# NEW CONSTRUCTION STAGE PROPERTY INSPECTION REPORT AS4349.0-2007

Type of Inspection Completed	Lock-Up/ Waterproofing
Have Architectural and/or Structural Engineering Plans been provided for this inspection:	Yes
<p>It is the responsibility of you (the client) to provide us (the inspector) with a full set of construction and engineering drawings for us to compare the construction drawings to what is being built on site.          Without these drawing we can Not comment on incorrect home and room dimensions, specified levels, engineer specifications and any relevant Australian Standards that has been referenced for the project.</p>	
Prevailing weather conditions at the time of inspection:	Dry
In respect of significant items:	
Was there any MAJOR DEFECTS evident from this inspection?	Yes
Was there any MINOR DEFECTS evident from this inspection?	Yes

**Location:** All bathrooms and ensuites

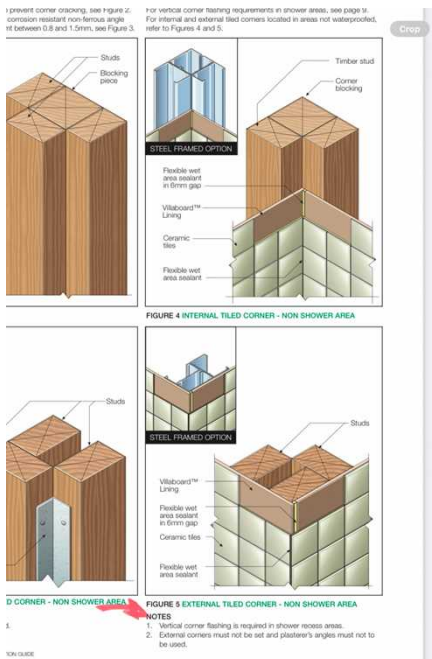
**Details:** Villaboard wall sheets have not been installed as per manufacturer's requirements.

James Hardie requires 6mm gaps at all junctions for thermal expansion which should be filled with suitable caulking.

Not complying with installation manual voids the product warranty from James Hardie.

I recommend talking to James Hardie reps as this has been done from multiple builders, they will confirm product warranty will be void.

**Recommendation:** All internal corners and external corners, both in wet and not wet areas (bathrooms) must have all base coat removed and paper tape and be replaced with joint sealer.

**Location:** Example of main bedroom ensuite. Defect applies to all bathrooms and ensuite.

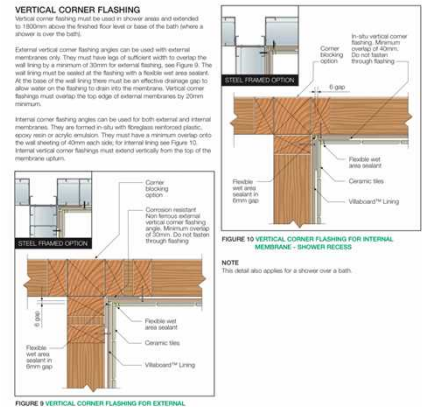
**Details:** Metal external corner installed to wet area , internal corners based coated and set with paper tape.

This is not consistent with James Hardie installation requirements.

**Recommendation:** All external corners and internal corners must be leaned from base coat , metal corners and paper tape and be replaced with caulking as per James Hardie instructions manual.

**Location:** Waterproofing product used onsite.

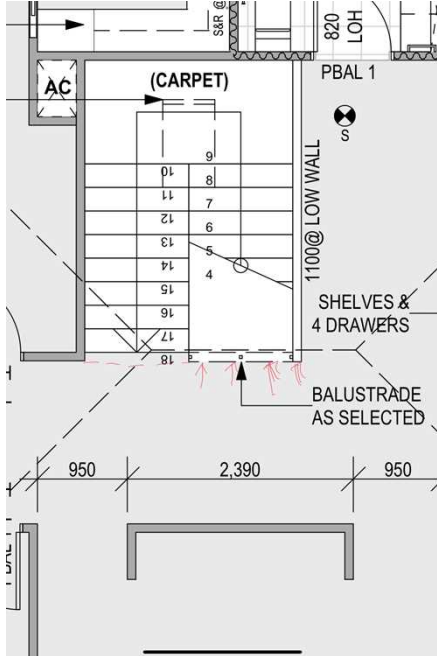
**Details:** As per this product and all products on the market all sheet junctions vertical and horizontal must have a bond breaker.

As mentioned in the data sheet, the sheet must be installed as per manufacturer's requirements.

The other item I would like to share is the product recommends bandage be used on all junctions for optimum performance. This is consistent with the other products on the market.

**Recommendation:** When waterproofing is repaired it must comply with the waterproofing installation manual.

**Location:** Powder room.

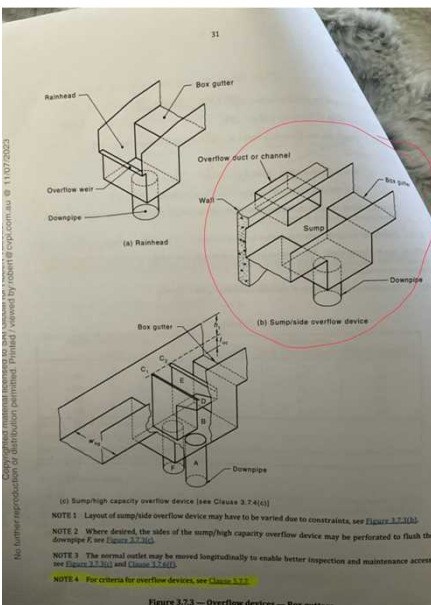
**Details:** Examples of all junctions and sheet joins with paper tape and base coated.

No bandage used on any junctions.

**Recommendation:** All waterproofing junctions to be rectified as per James Hardie installation manual, AS3740-2010 and waterproofing product installation requirements.

**Location:** Flashing to lower roof/ box gutter location.

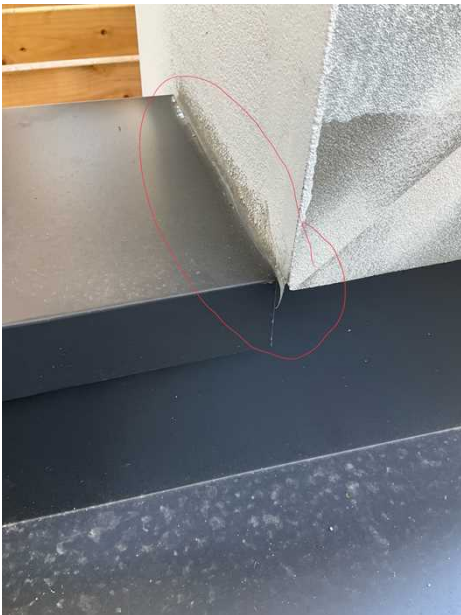
**Details:** Flashing is not installed behind the cladding as required.

Flashing not in bedded into masonry as required.

All flashing must lap by 75mm minimum and walk flashing must be integrated into the masonry. Compression flashing can be used but must comply with HB39 and have 100mm fixings max spacings.

**Recommendation:** Flashing to be fixed to comply with NCC requirements

**Location:** Front lower roof.

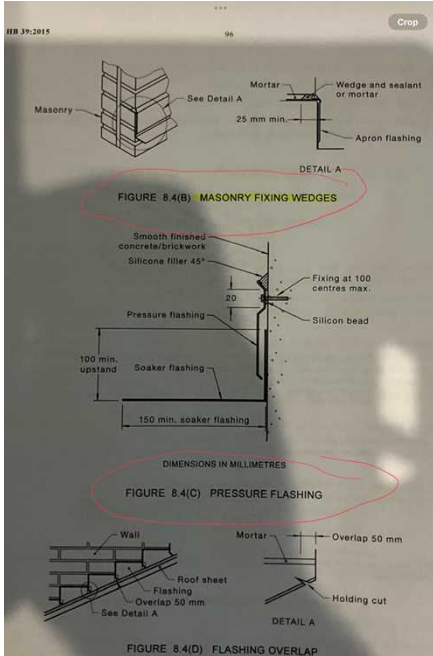
**Details:** Capping flashing wall junctions.

Primarily method to prevent water ingress is silicon.

This should have an over flashing/wall flashing/saddle flashing design in place.

**Recommendation:** Recommend installing an overflashing cut into masonry or pressure flashing complying with HB39.
